RE: Celebree School – 3025-3035 Zinn Road
Conditional Use Review
Caln Township
ARRO No.: 11243.55

As requested, we have completed a review of the Conditional Use Application submitted for the proposed Celebree School. The property is located at 3025-3035 Zinn Road, UPI Nos. 39-4-91.16A and 39-4-91.16B. The Plan intends to merge the lots comprising the property and to reuse the existing building on the property for a child daycare center.

CONDITIONAL USE PLAN
 CLIENT: CELEBREE SCHOOL
 PROJECT: PROPOSED CELEBREE SCHOOL
 LOCATION: 3025 & 3035 ZINN ROAD
 CALN TOWNSHIP, CHESTER COUNTY, PA

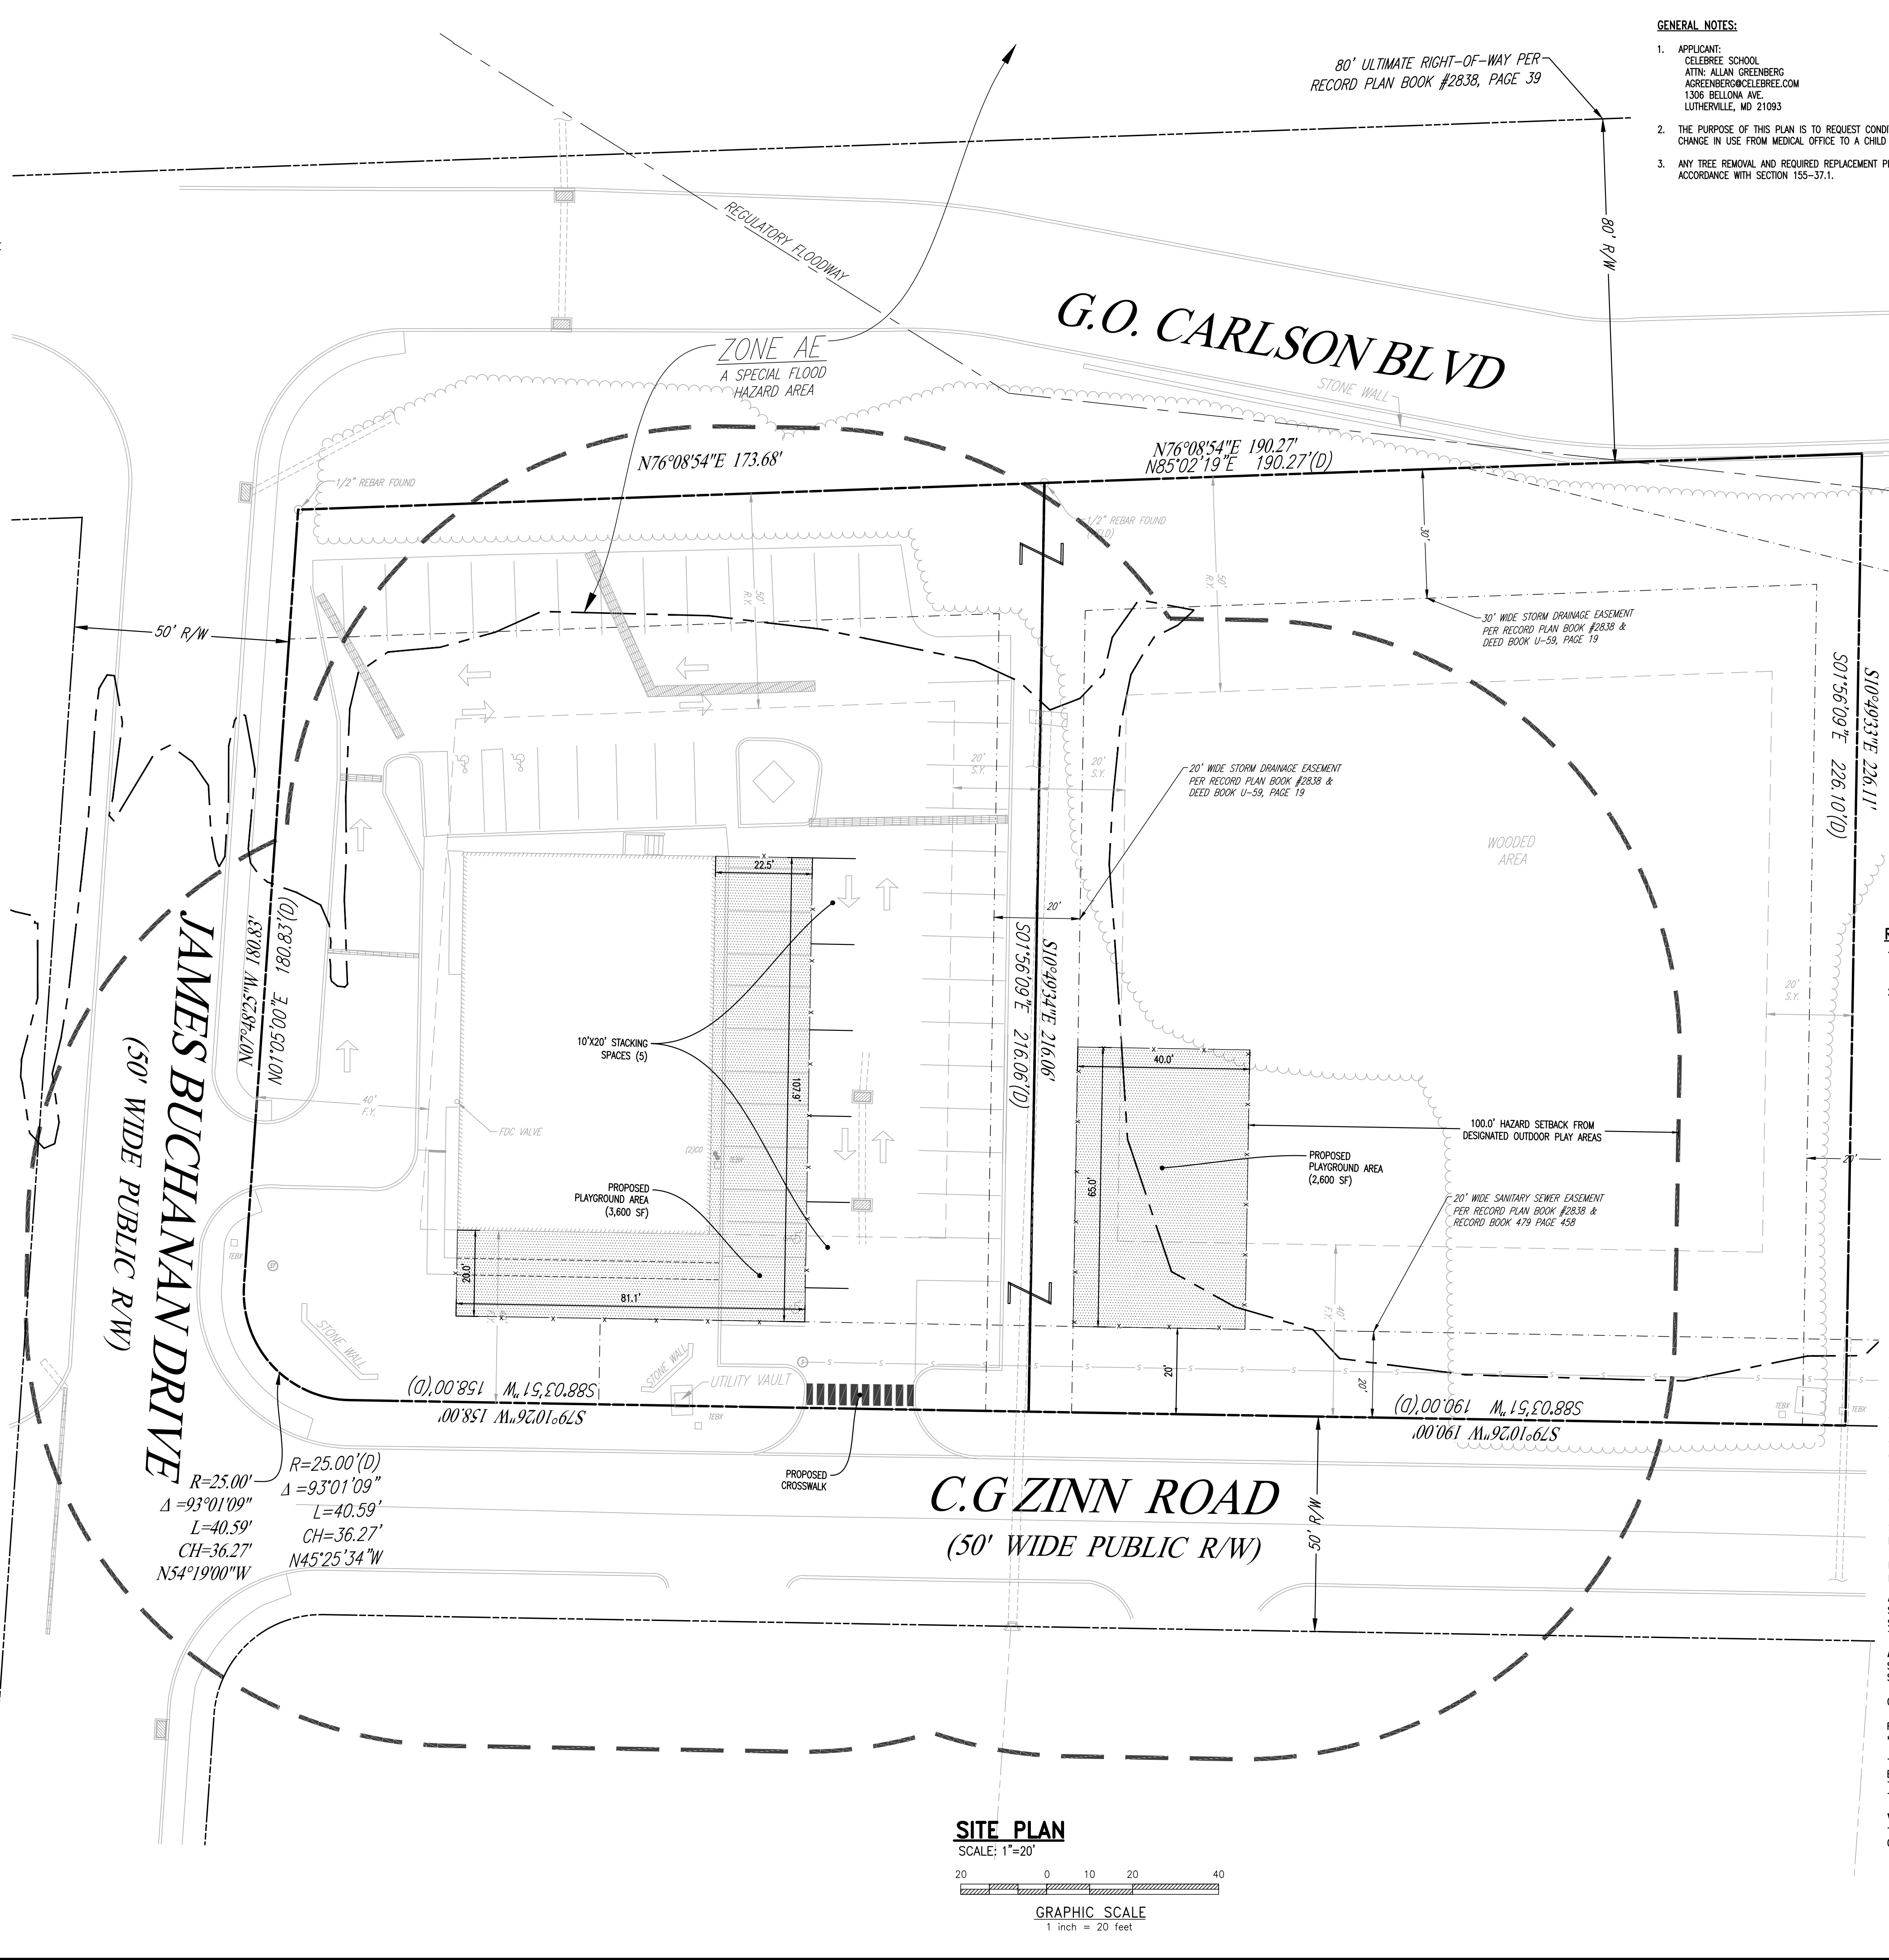
The Applicant has requested modifications of §155-70.D(4)(c) to permit fencing around the play areas to be six (6) feet in height and to permit a turf surface instead of grass or lawn in parts of the play area. ARRO offers no objection to the requested modifications. The Applicant should provide an explanation of the proposed use of the outdoor play area and the number of children that the outdoor play area will accommodate. If the area will not accommodate all children at once, then further modification of this section may be required.

The pickup/dropoff stacking spaces appear to be on the opposite side of the building from the entrance/exit, and sidewalk is not provided to the pickup/dropoff spaces.

The proposed stacking spaces along the east side of the building reduce the parking aisle to less than the required 24 feet.

The proposed play area will block the existing sidewalk around the south side of the building. Pedestrian access shall be provided along the south side of the building, from the building to the proposed pickup/dropoff stacking spaces and to the proposed satellite playground area. There are no existing sidewalks along Zinn Rd. Sidewalks also may be required as part of subdivision and land development.
